UNITED STATES PATENT AND TRADEMARK OFFICE

10/661,545

Kenji Samoto

DETAILED ACTION

Drawing A: Figure 5 from Lim, edited for clarification of rejection

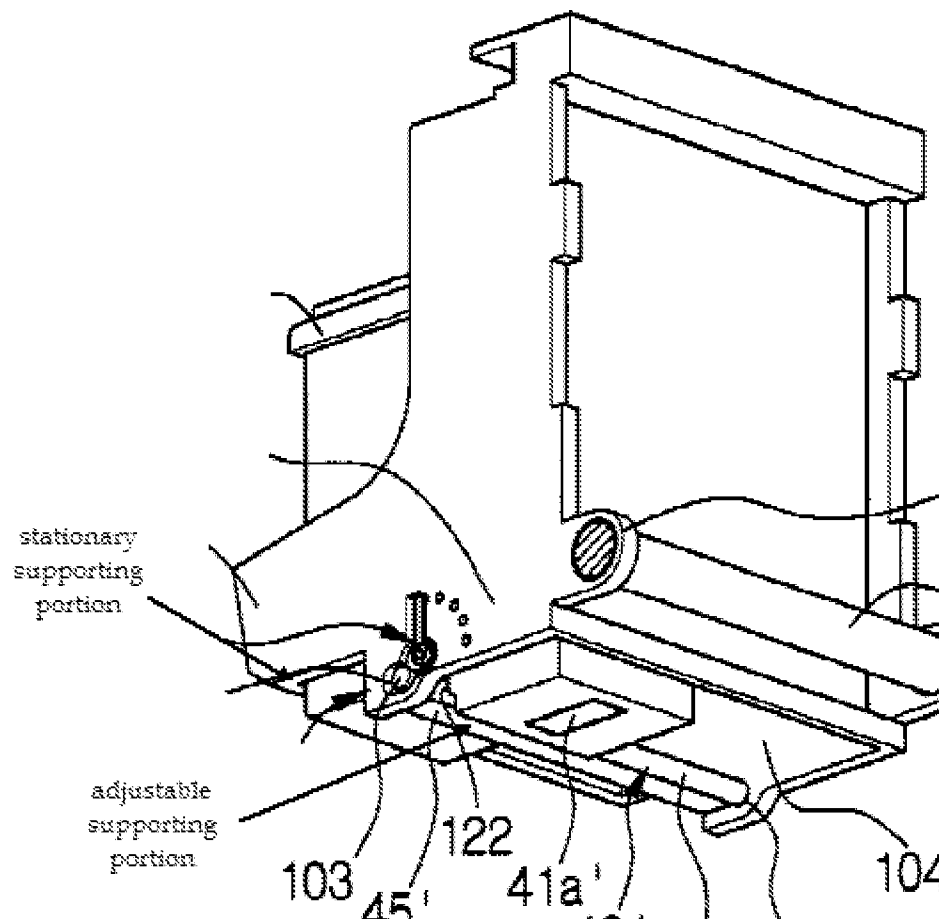
a plurality of supporting portions having respective supporting points where the supporting portions engage and support the recording head (see Drawing A below); and

at least one adjusting device (cam 113 + lever 115) that moves the supporting point of at least one adjustable supporting portion (portion of adjustment shaft 102 supporting lower fixing surface 122) of the supporting portions toward, and away from, the recording medium (col. 5, lines 20-30 & Figs. 2 and 6 show that the head 41' is moved toward and away from the paper P in paper feeder 20), the supporting portions further comprising at least one stationary supporting portion whose supporting point is stationary (Drawing A),

the at least one adjustable supporting portion (102) being provided at a rear position of the carriage so as to define a rear clearance between a rear portion of the recording head and the recording medium (Figs. 2 & 5),

the at least one stationary supporting portion being provided at a front position of the carriage so as to define a front clearance between a front portion of the recording head and the recording medium (Fig. 2 & Drawing A),

the at least one adjusting device (100) moving the supporting point of the at least one adjustable supporting portion (102) and thereby adjusting the rear clearance between the rear portion of the recording head and the recording medium (Figs. 2 & 5 show that the clearance between the head 41' and the paper P in paper feeder 20 is changed).

Lim as modified by Numata et al. disclose all the limitations of claim 10, and **Lim also discloses** two front stationary supporting portions (each corner between the front and sidewalls comprises a stationary supporting portion - Drawing A) and one rear adjustable supporting portion (Drawing A).

Lim as modified by Numata et al. disclose all the limitations of claim 13, and **Lim also discloses** that the two front stationary supporting portions are provided in a vicinity of the two

side plates, respectively (Drawing A), and the one downstream adjustable supporting portion is provided at a substantially middle position between the two side plates (Fig. 5).
